DRB SUBMITTAL

CAR CARE CENTER / SALES
San Mateo / Alameda, N.E.
Albuquerque, New Mexico

CONCEPTUAL
GRADING
PLAN

Sheet:
C-2

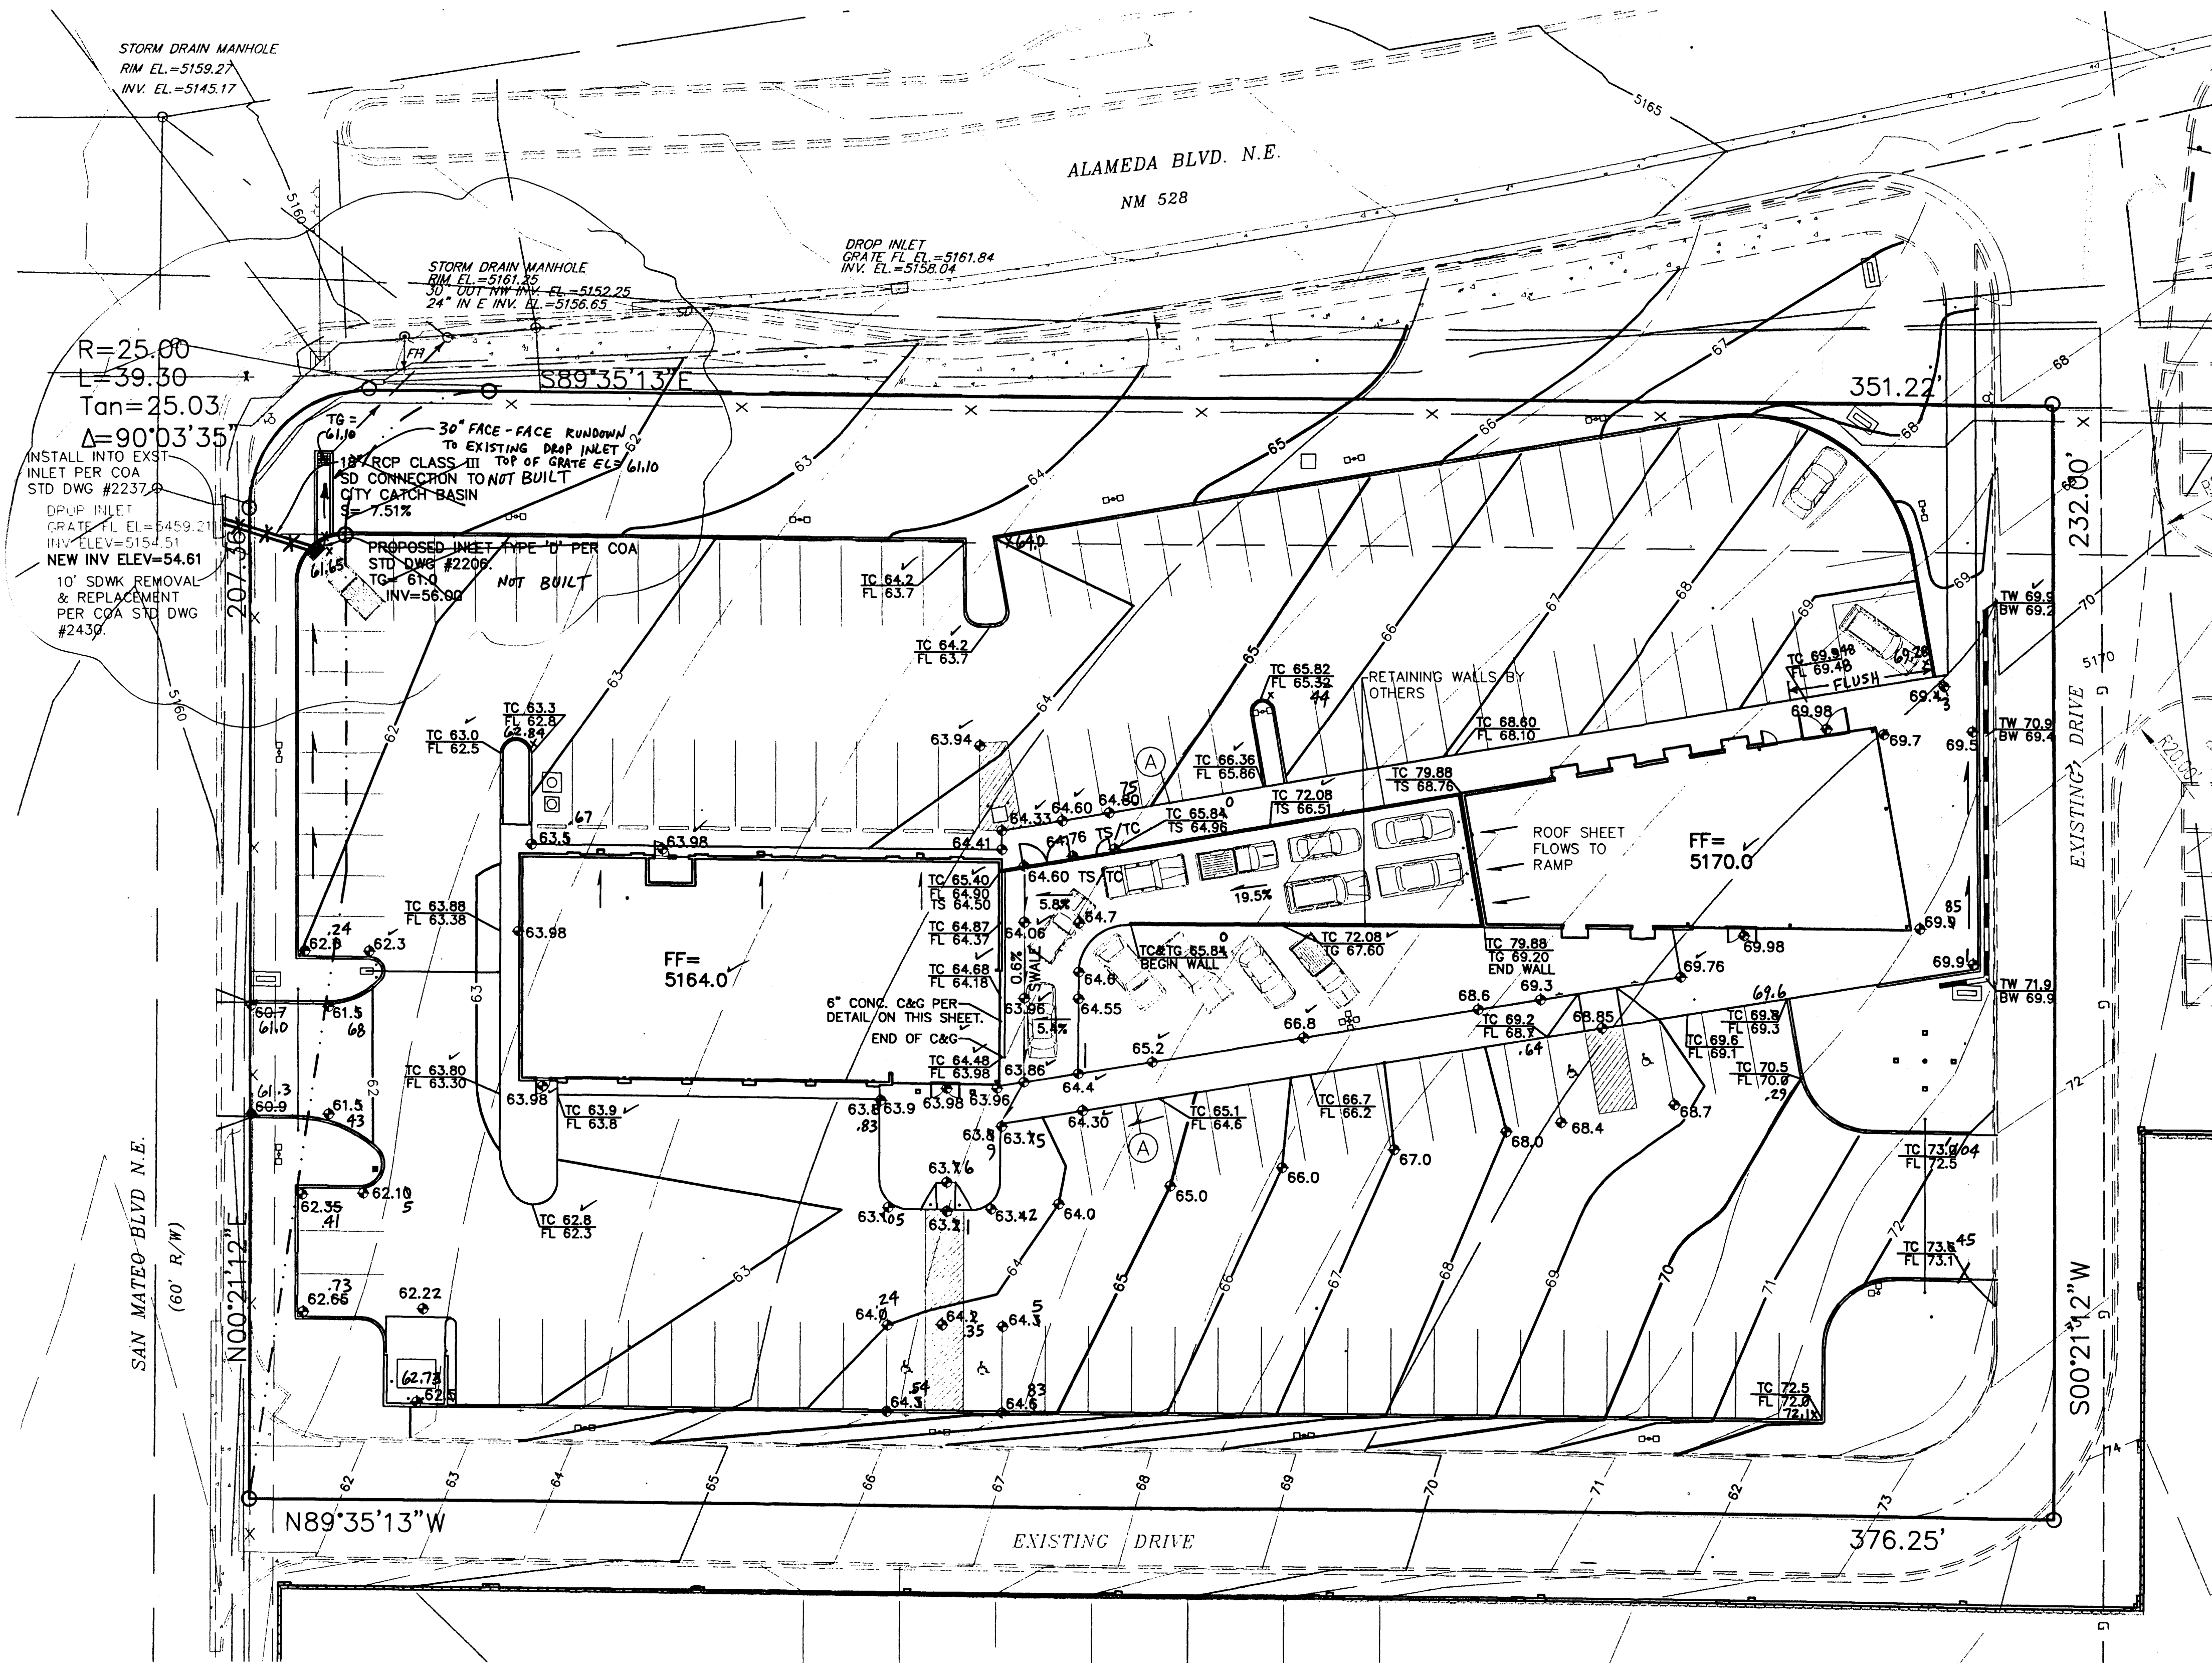
BLB approved at DRB
Chuck Carmax for
flow restrictions

Sheet: 8 Of 49
C-1.0

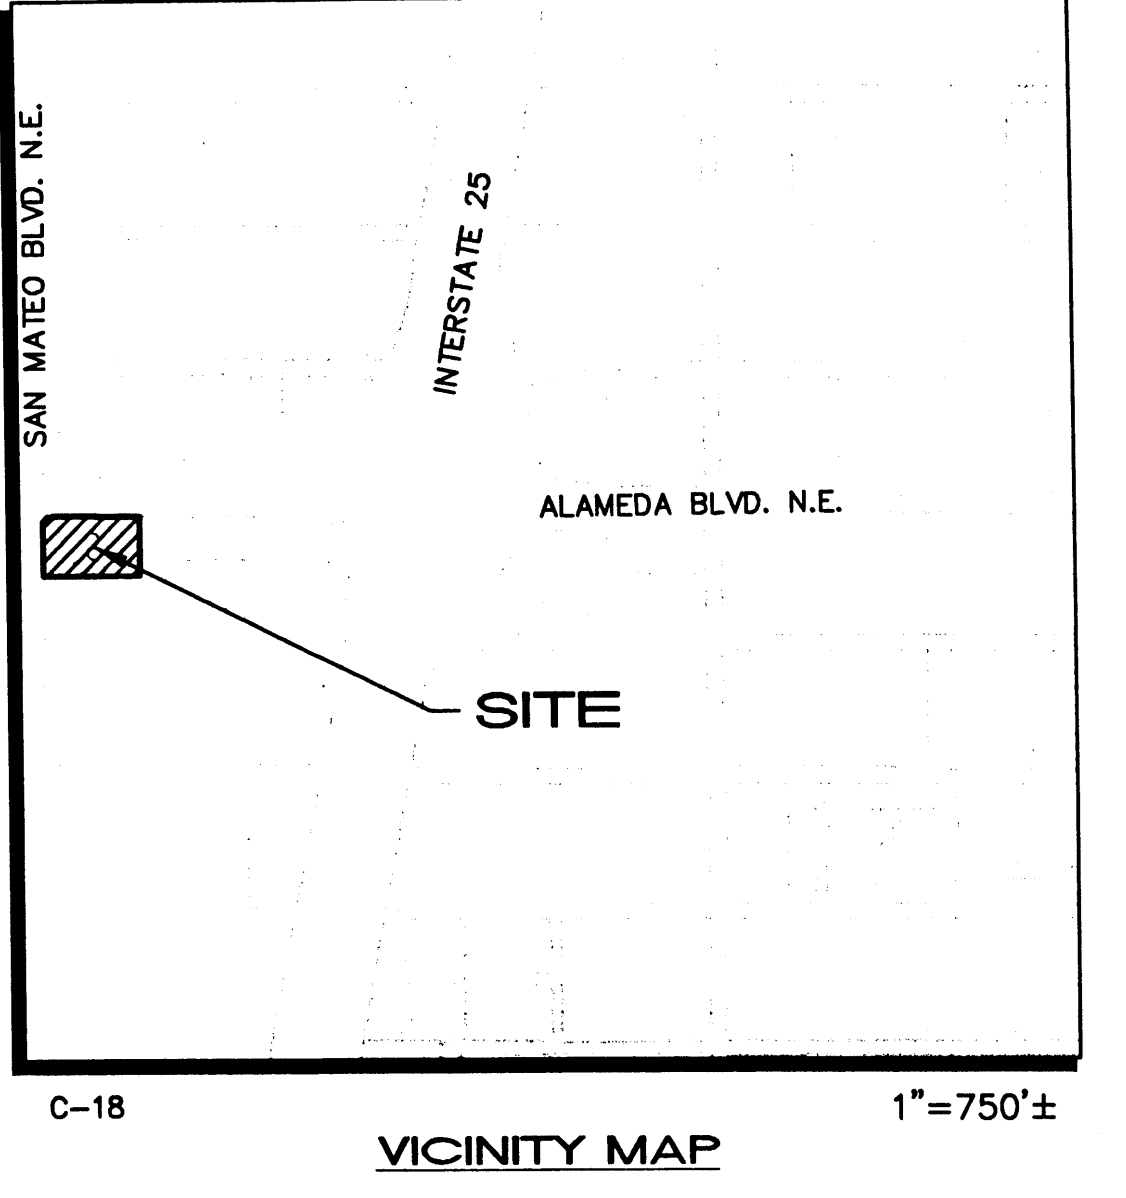
ENGINEER'S CERTIFICATION
I, SCOTT M. MCCREE, LICENSED UNDER THE LAWS OF THE STATE OF NEW MEXICO, DO HEREBY CERTIFY THAT THIS PROJECT WAS CONSTRUCTED IN SUBSTANTIAL COMPLIANCE WITH THE APPROVED PLAN (CITY APPROVAL LETTER DATED 02/10/05). THE PROPOSED CONNECTION TO THE CITY INLET WAS NOT REQUIRED AS A 30-INCH CONCRETE UNIDIRECTIONAL CURB AND GUTTER TO AN EXISTING ON-SITE DRAINAGE INLET WAS PROVIDED TO DISCHARGE TO THE CITY INLET. GENERAL CONTRACTOR ON 07/10/05 IN ACCORDANCE WITH THE "NEW MEXICO ENGINEERING AND SURVEYING ACT" SECTION 61-23-1 THROUGH 61-23-32 NMSD (1978).

NOT REQUIRED
